Final Environmental Assessment

**Grand Junction
Conversion
Transmission Line
Project**

FINAL ENVIRONMENTAL ASSESSMENT
ON THE
GRAND JUNCTION CONVERSION TRANSMISSION LINE PROJECT
AND AN AMENDMENT TO THE
ROAN CREEK/WINTER FLATS MANAGEMENT FRAMEWORK PLAN

This document is an abbreviated FEA which means that it includes only corrections to the draft, comment letters with responses, and additional analysis which was conducted subsequent to the DEA in response to public and agency comments.

Figure 2-11 Revised

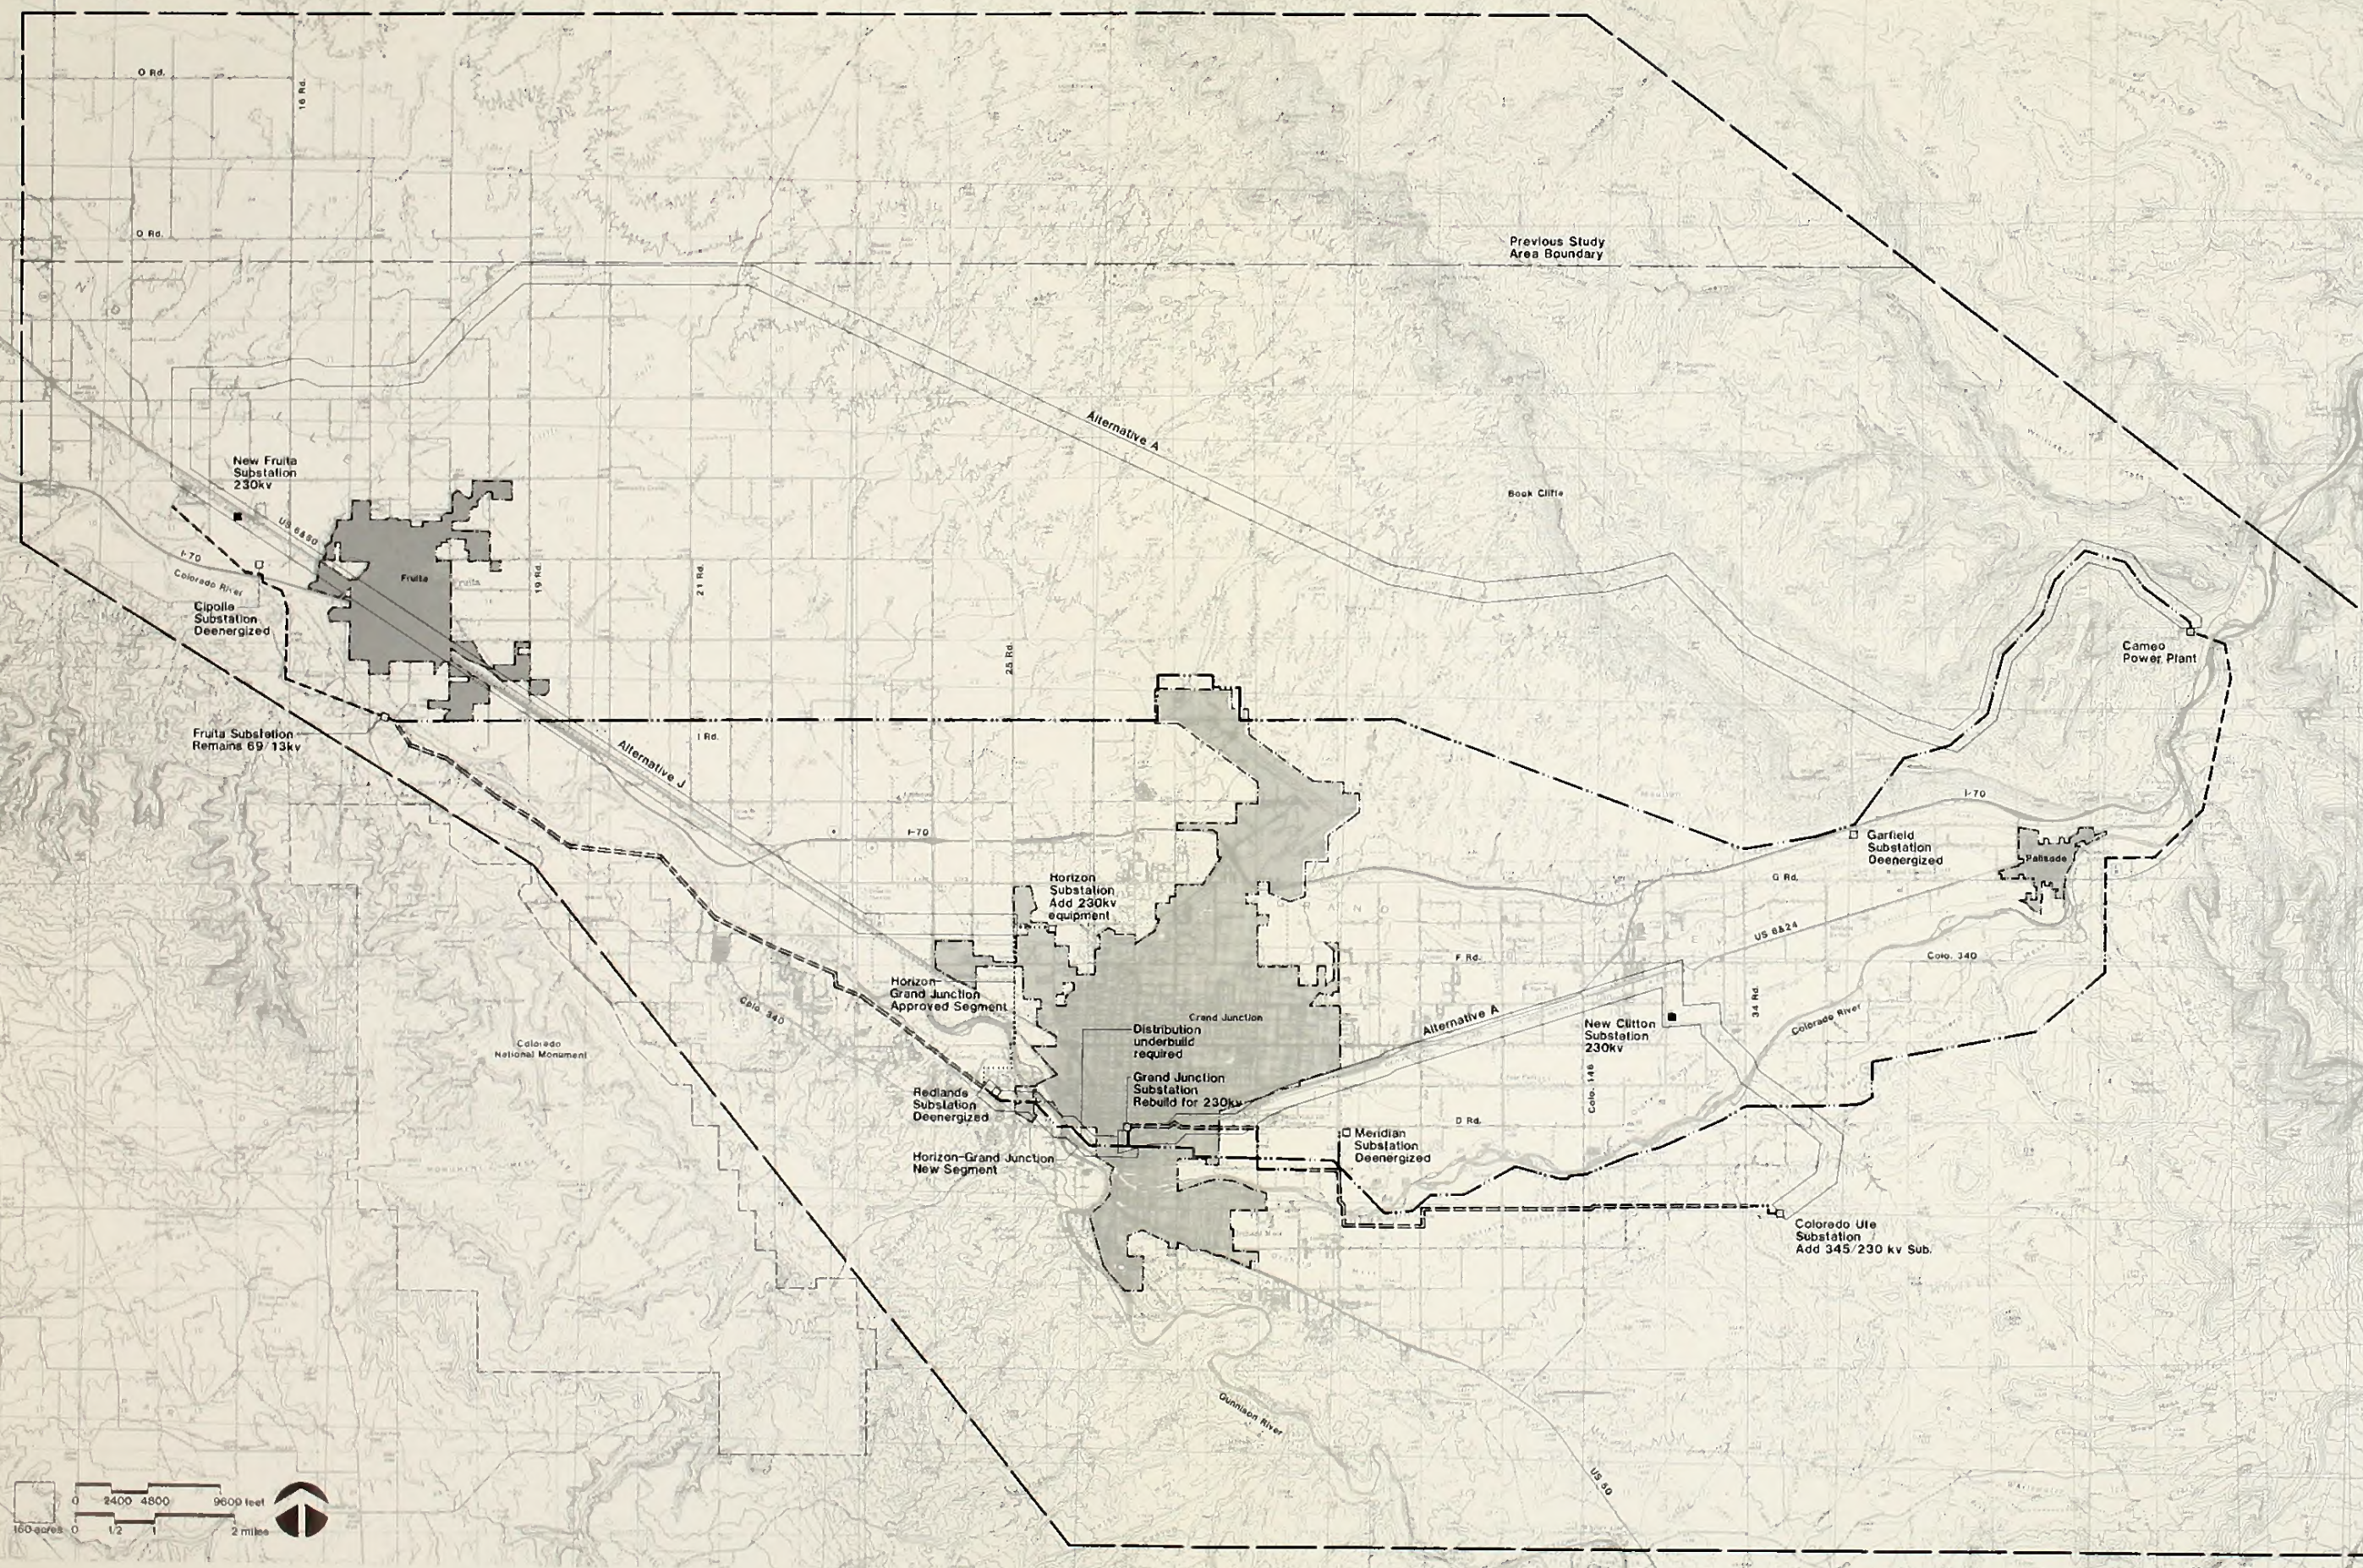
Replace Section **e, Utilization of Existing 69-kV Lines**, with the following:

Certain segments of the existing 69-kV line are proposed to be abandoned, used for distribution, or remain in service. (See Revised Figure 2-11 and Revised Table 2-5). The portions which are to be abandoned will be dismantled, removed from the right-of-way, and the disturbed areas revegetated, using the same seed mixtures as shown for the new transmission lines. (See Tables 2-10 and 2-11 in the DEA).

Figure 3-8 Revised

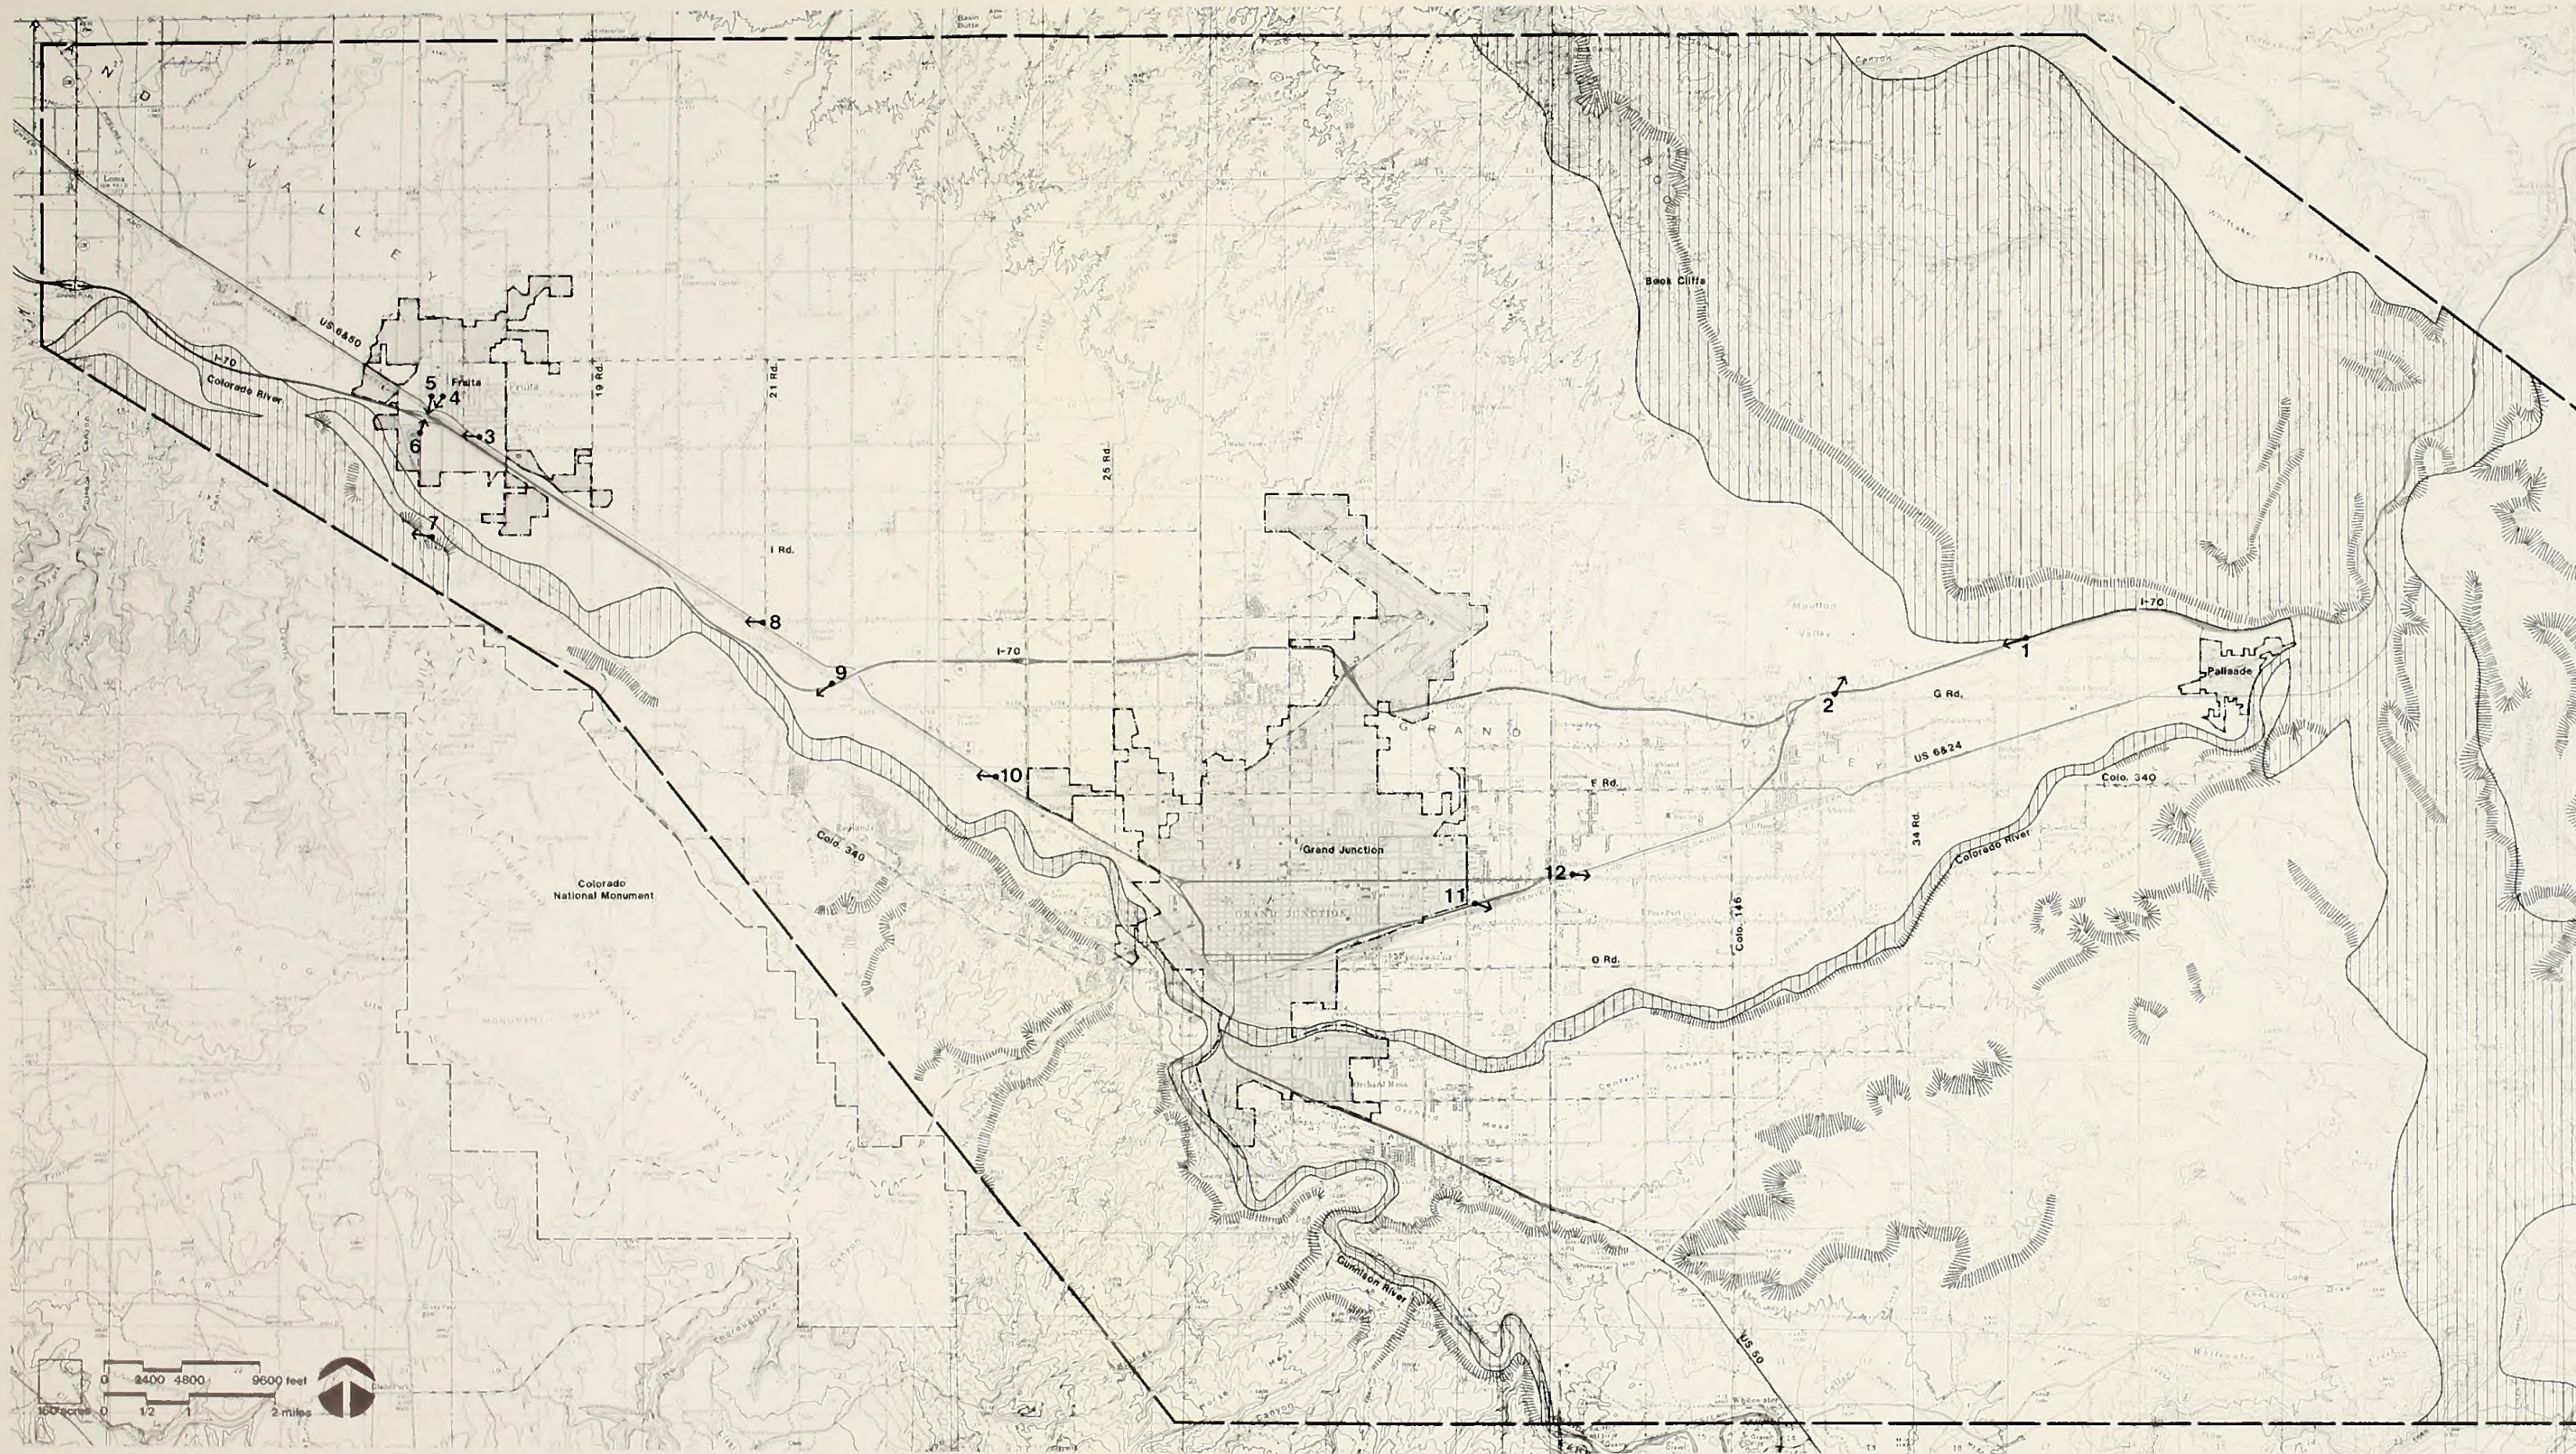
Revised Figure 3-8 identifies key viewpoints with respect to the proposed project from which a series of twelve visual simulations were prepared. These visual simulations showing before and after views of the transmission line appear in Chapter 4 (Figures 4-1 through 4-12).
